DART AEROSPACE LTD		Work Order:	140425
Description: Crosstube Assembly		Part Number:	D407-667-145
Inspection Dwg: D407-667-145 Rev: C		Page 1 of 2

DART AEROSPACE LTD HAWKESBURY, ONTARIO, CANADA	
DRAWING NO. D407-667-145	REV. C SHEET 1 OF 4
TITLE CROSSTUBE ASS'Y (407 HIGH FWD)	SCALE NTS
COPYRIGHT © 2002 BY DART AEROSPACE LTD THIS DOCUMENT IS PRIVATE AND CONFIDENTIAL AND IS SUPPLIED ON THE EXPRESS CONDITION THAT IT IS NOT TO BE USED FOR ANY PURPOSE OR COPIED OR COMMUNICATED TO ANY OTHER PERSON WITHOUT WRITTEN PERMISSION FROM DART AEROSPACE LTD.

DRAWING NO. D407-667-145	TITLE CROSSTUBE ASS'Y (407 HIGH FWD)	REV. C	DART AEROSPACE LTD ENGINEERING ORDER		D.E.O. NO. D407-667-145-C-1	SHEET NO. SHEET 1 OF 1	SCALE NTS
DRAWN 9	CHECKED SS	MFG. APPR. 18	APPROVED WD		DE APPR. H		
DATE 11.07.15	DATE 11.07.22	DATE 11.07.22	DATE 11/07/22		DATE 11.07.21

DRAWING NO. D407-667-145	TITLE CROSSTUBE ASS'Y (407 HIGH FWD)	REV. C	DART AEROSPACE LTD ENGINEERING ORDER	D.E.O. NO. D407-667-145-C-2	SHEET NO. SHEET 1 OF 1	SCALE NTS
DRAWN AJS	CHECKED A	MFG. APPR. E	APPROVED 160	DE APPR. H		
DATE 12.08.02	DATE 12.08.02	DATE 12.08.02	DATE 12.08.02	DATE 12.08.02	DATE 12.08.02

DETAIL P
BONDING STRAP INSTALLATION 2 PL

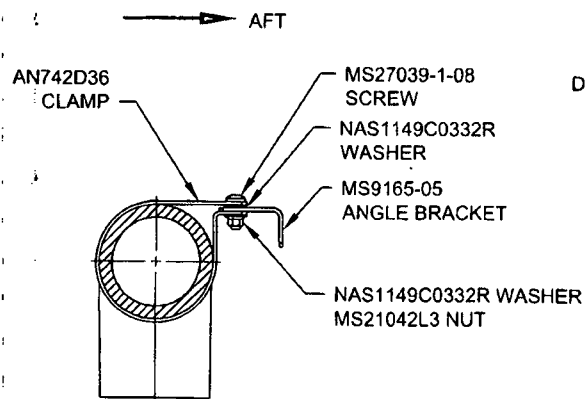
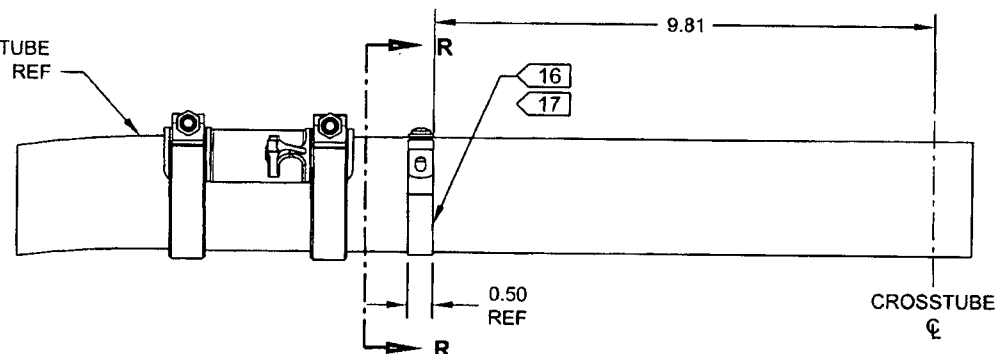
ADD ELECTRICAL GROUNDING STRAP

ITEM	QTY -145	PART NUMBER	DESCRIPTION
1	X	D407-667-145	CROSSTUBE ASSEMBLY (407 HIGH FWD)
10	2	AN742D36	CLAMP
11	2	MS9165-05	ANGLE BRACKET
12	2	MS21042L3	NUT (OR MS21042-3)
13	2	MS27039-1-08	SCREW
14	4	NAS1149C0332R	WASHER (OR AN960C10L)

- 16) MASK AREA UNDER CLAMP PRIOR TO PAINTING
- 17) SEAL EDGES WHERE AN742D36 CLAMP MEETS WITH THE CROSSTUBE USING SIKAFLEX-241/-291 OR MIL-S-8802 CLASS B2 OR PROSEAL 890 SEALANT
- 18) PERFORM RESISTANCE CHECK TO ENSURE MAX RESISTANCE IS 10 MILLIOHMS
